Peach Bottom Atomic Power Station, Units 2 and 3

Extended Power Uprate License Amendment Request – Supplement 11

Response to Request for Additional Information

Response to Request for Additional Information - AHPB-HP

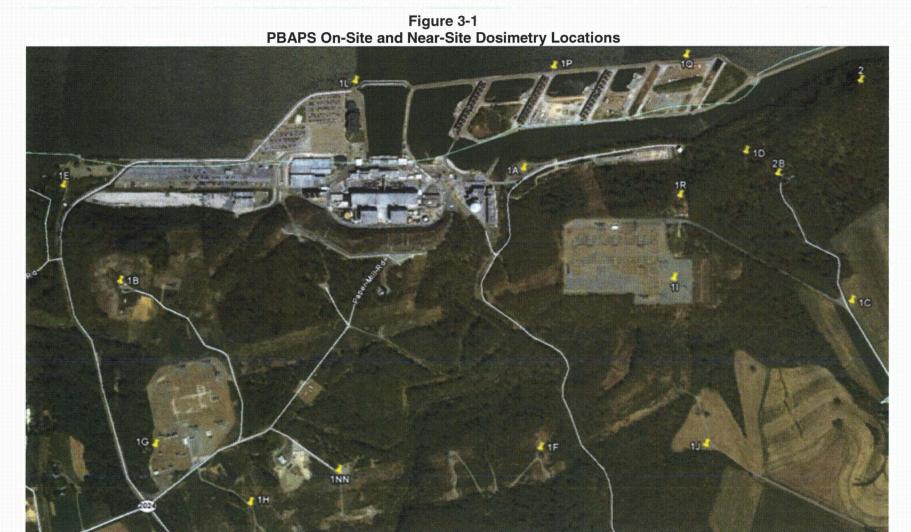
PUSAR page 2-514, 1<sup>st</sup> paragraph, and Table 2.10-2, indicate that the post-EPU N-16 skyshine dose rate at the nearest boundary is negligibly small. Provide a quantitative basis for this conclusion. Provide all input parameters (e.g., source strength, exposure geometries, distance to nearest boundary) needed to calculate the skyshine contribution to the most exposed member of the public during EPU operations.

The EPU dose evaluation utilizes measured data, taken from the dosimetry location nearest the turbine hall, to quantify the skyshine dose contribution. The location nearest the turbine hall is appropriate because the N-16 skyshine dose is a function of distance from the source, and the skyshine dose decreases with increasing distance.

Figure 3-1 is an aerial view of the PBAPS site, and it is annotated to show the PBAPS Offsite Dose Calculation Manual (ODCM) (Reference 1) Table VII.A-1 dosimetry locations. Figure 3-1 shows that on-site location 1L is the dosimetry location nearest the turbine hall - approximately 1.250 feet north-east.

Figure 3-1 also shows location 1E, the dosimetry location corresponding to the public access point nearest the station - approximately 3,000 feet north-west of the turbine hall. Because this location is further from the source than location 1L, the skyshine gamma dose at location 1E must be lower than at location 1L. Because the skyshine gamma dose at location 1L is negligible, the skyshine dose to a member of the public at location 1E is also negligible.
